MIDLAND ENERGY CENTER  
MIDLAND DOCKET NOS 50-329, 50-330  
NRC REQUEST FOR ADDITIONAL INFORMATION ON THE  
SEISMIC MARGIN REVIEW REPORT  
FILE: B3.7.1 SERIAL: 25479

REQUEST FOR ADDITIONAL INFORMATION

130.29 Provide the following additional information with respect to Volume VI of the Seismic Margin Review report titled, "Borated Water Storage Tank and Foundation" transmitted by your letter of February 16, 1983.

FIGURE Q&R 130.29.1-1 TOP-OF-FILL SME RESPONSE SPECTRUM

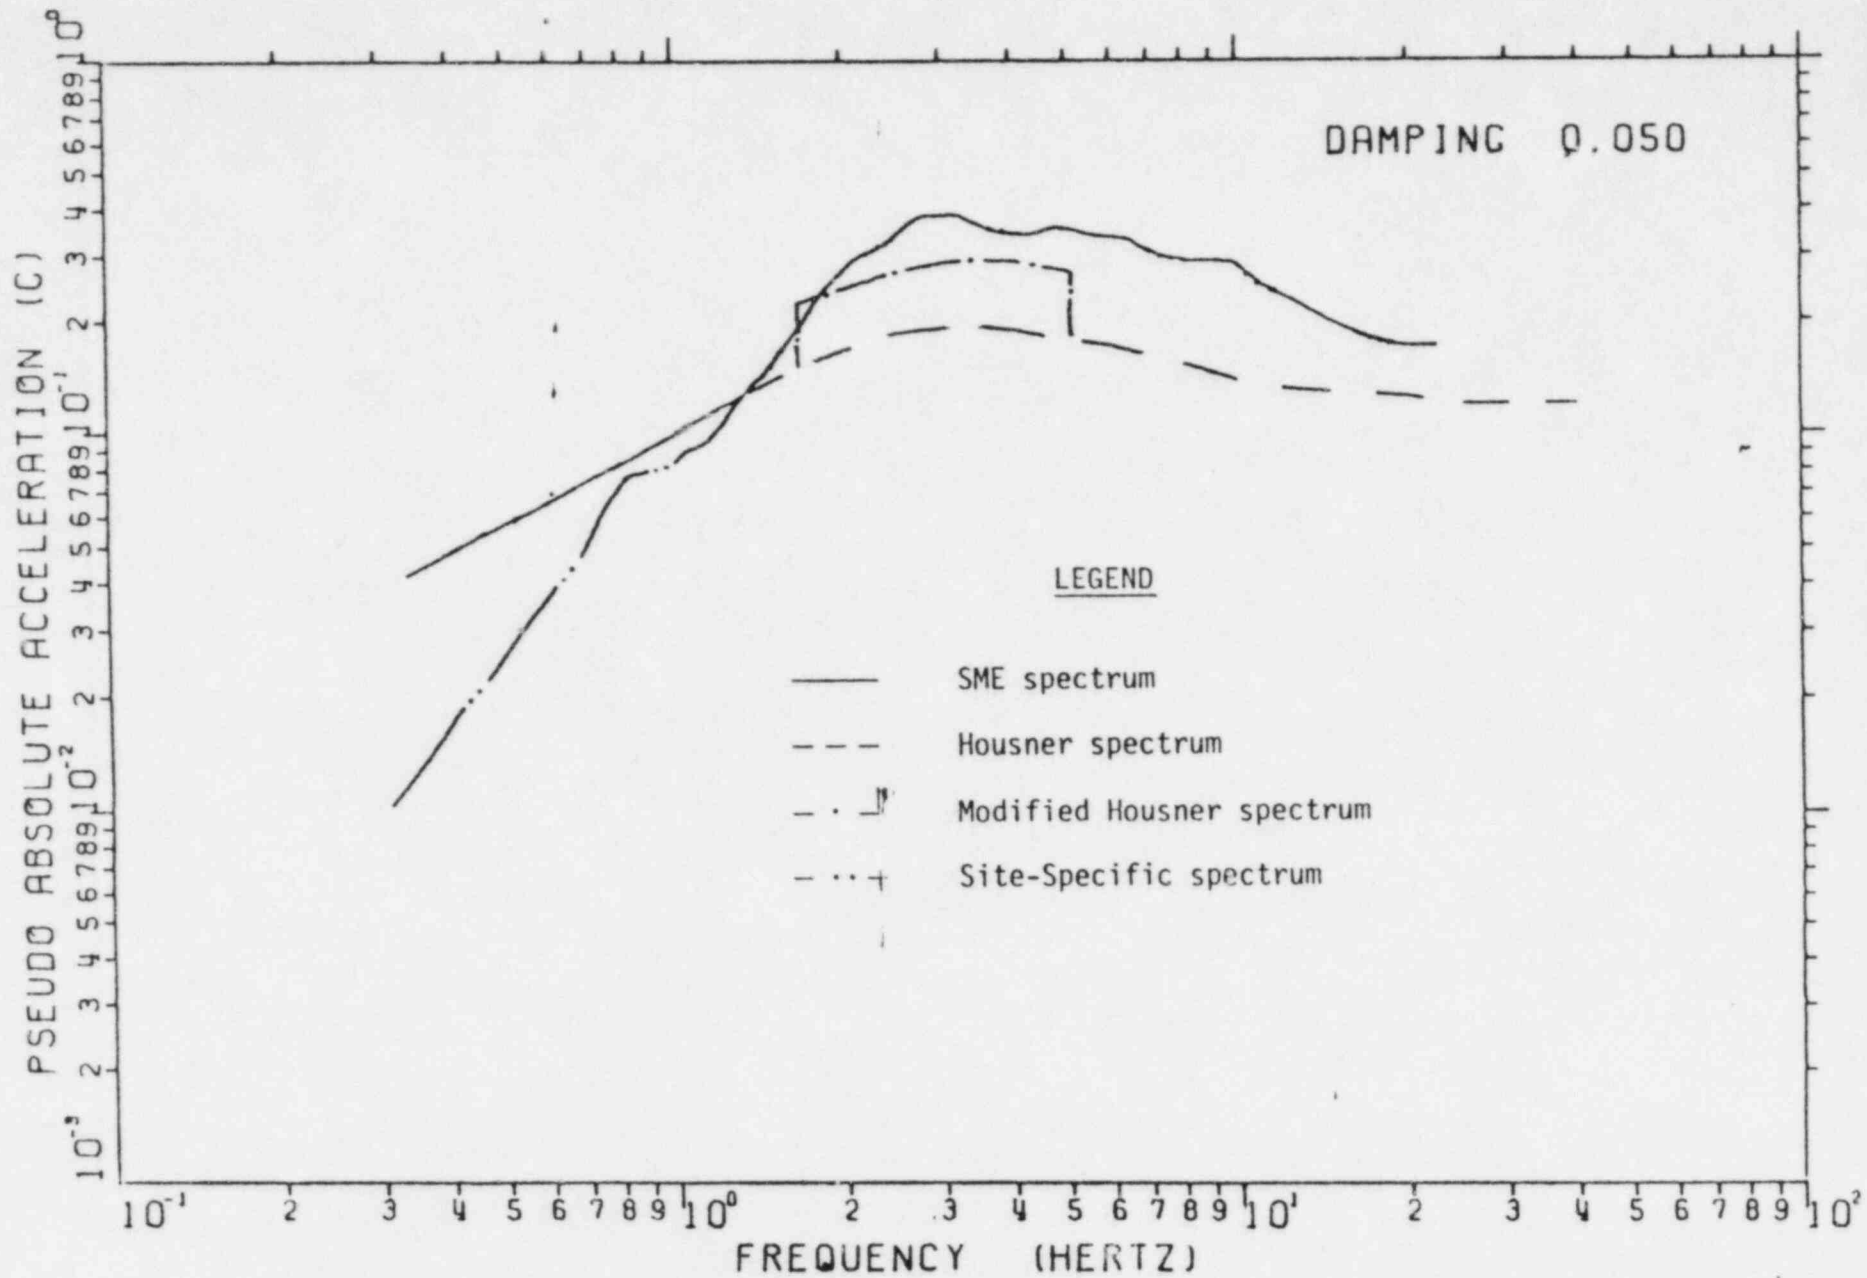
Question 130.29.1 Clarify in Section 1.1 that a modified Housner response spectrum is used in the development of the SME and not just the Housner response spectrum.

Response: The SME response spectrum used for the structural evaluation of the BWST was the envelope of the Housner spectrum and the site-specific response spectrum developed for structures founded at the top-of-fill at the Midland site. Clarification of the use of the Housner spectrum versus the modified Housner for the SME occurred during cross-examination of Dr. Richard J. Holt before the Atomic Safety and Licensing Board on October 13, 1981 (Reference 1). During this testimony it was specifically stated that the original Housner spectrum and not the modified Housner spectrum would be used in the development of the SME spectrum. The SME, site-specific, Housner, and modified Housner response spectra are illustrated in Figure Q&R 130.29.1-1.

For this SME evaluation, it is appropriate to utilize earthquake response spectra which are representative of actual earthquakes which might occur at the Midland site (with low probability of being exceeded). The site-specific response spectrum is representative of actual earthquake motion although it has been broadened to account for uncertainties in earthquake frequency content and site conditions. The Housner spectra, which is the envelope of spectra from actual earthquake time histories, is included in the SME definition to assure that conservative earthquake ground motion is accounted for in the low frequency regime. The Modified Housner response spectrum is unrealistic because no real earthquake ground motion would produce this response spectrum.

FIGURE Q&R 130.29.3-1 COMPARISON OF ACTUAL AND APPROXIMATE HYDRODYNAMIC PRESSURE DISTRIBUTIONS FOR VARIOUS TANK MODE SHAPES

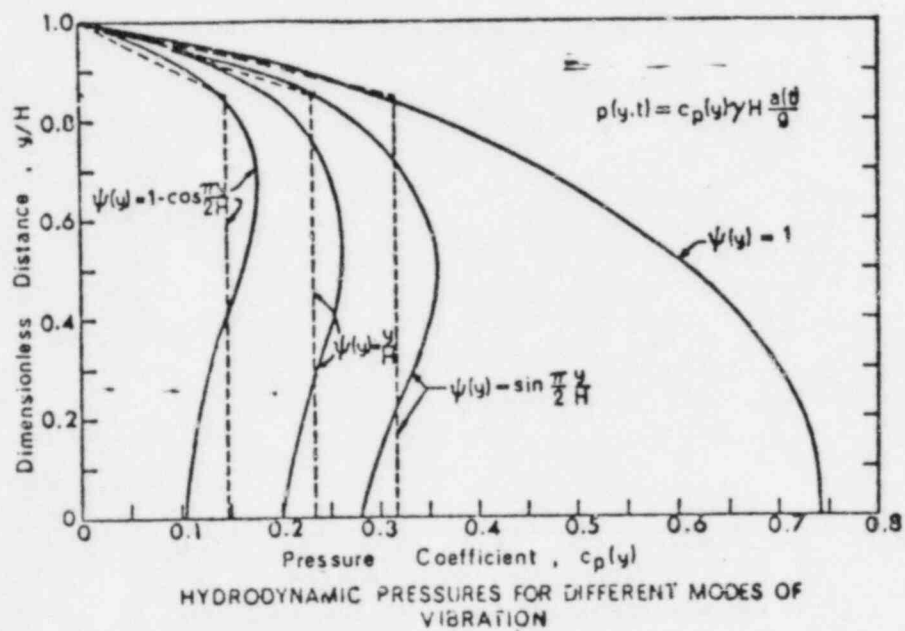
- a. Discuss in more detail why the model identified in Figure VI-2-2 is a better representation than the model in Figure VI-2-1.
- b. State why you assume that the hydrodynamic pressure is constant from elevation  $y = 0.15h$  to the bottom of the tank.
- c. Provide a comparison between the methods identified in References 6 and 7. A summary of specific assumptions, model and results should be provided for staff review.
- d. Address the development of the constant 1.453 in Equation 2-3.
- e. Address Equation 2-4 by providing a specific reference within Reference 2 and/or providing a copy of related pages.

- a. Figures VI-2-1 and VI-2-2 do not represent separate models for evaluating BWST horizontal impulsive mode response. Figure VI-2-1 is shown for the purpose of illustrating how the impulsive fluid mass is lumped to the various degrees of freedom in the model. Figure VI-2-2 provides the actual numerical values describing the model in detail including weights, dimensions, and beam and soil spring properties.
- b. The idealized hydrodynamic pressure distribution in which the pressure increases linearly from zero at the top of the fluid ( $y = 0$ ) to the constant value from Equation 2-3 at  $y = 0.15$  and greater is based on the recommendation of Reference 6. This distribution is a reasonable approximation as shown in Figure Q&R 130.29.3-1 (reproduced from Reference 6) by the comparison of actual and the approximate distribution for different tank mode shapes.

FIGURE Q&R 130.29.4-1 EFFECT OF ACCOUNTING FOR VERTICAL TANK/FLUID FLEXIBILITY

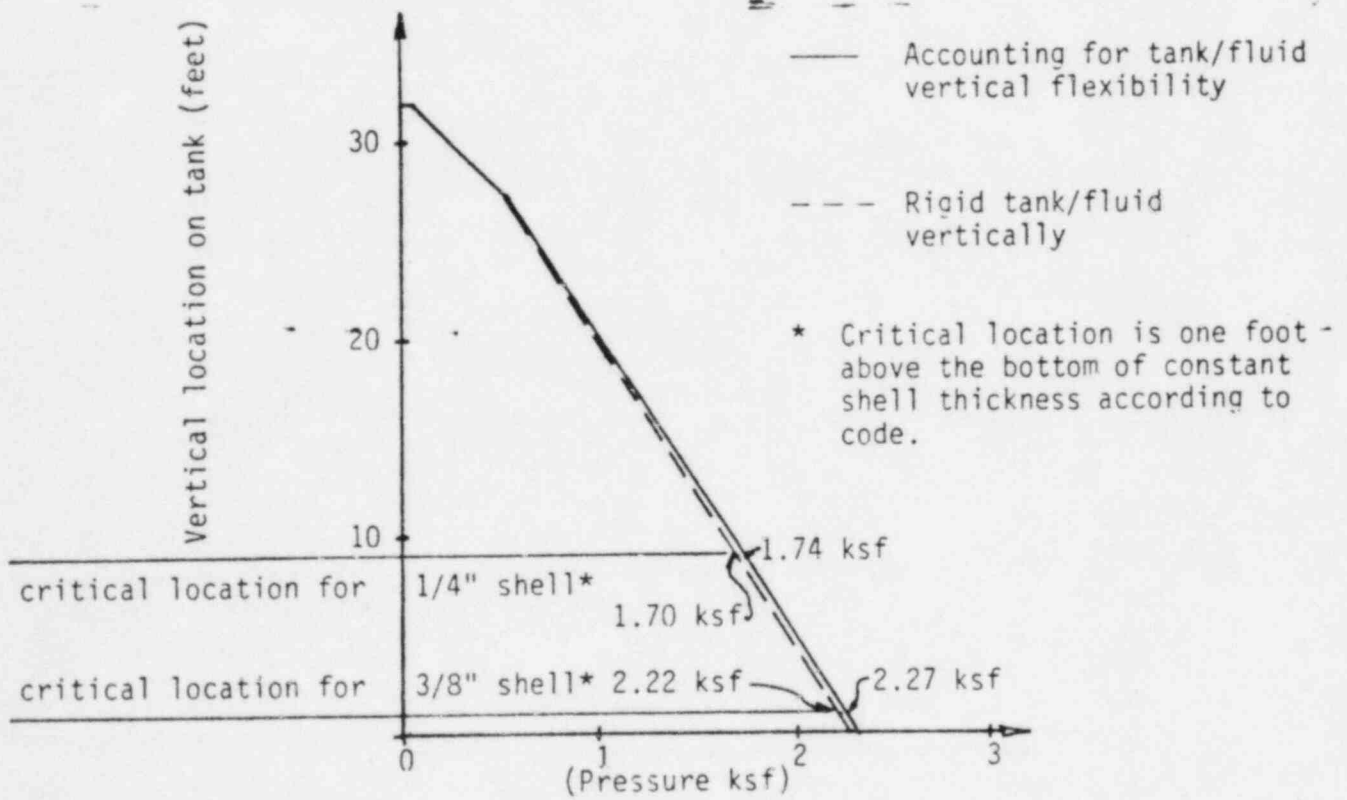
Question 130.29.4 With respect to Section 2.2.3, investigate and discuss results of the effect on the fundamental frequency and hydrodynamic pressures due to vertical ground motion for the borated water storage tanks.

The coupled tank-fluid-soil response for vertical seismic excitation has been computed by a model consisting of spring elements representing the tank and fluid which produce a fixed-base fundamental frequency of about 8.1 Hz and which is attached to ground by a vertical soil spring. The lower bound soil case is considered as this case produced the largest seismic response for horizontal excitation. The mode shapes and total wall pressures (i.e., combined hydrostatic and hydrodynamic pressures) are compared in Figure Q&R 130.29.4-1 for the rigid tank approximation and including tank/fluid vertical flexibility.

The results presented above indicate that the rigid tank approximation was adequate for the BWST evaluation. Although the vertical fundamental frequency is overestimated by about 10 percent, the maximum tank shell pressure (i.e., combined hydrostatic plus hydrodynamic pressures) is underestimated by only about 2 percent. The resulting minimum hoop stress code margin, CM, and seismic margin,  $F_{SME}$ , as reported in Section 4.4.2, are changed from 2.13 and 8.40 to 2.08 and 7.28, respectively, when vertical flexibility is accurately accounted for. Thus, the conclusions of the BWST report are not significantly affected by the rigid tank approximation for vertical ground motion.
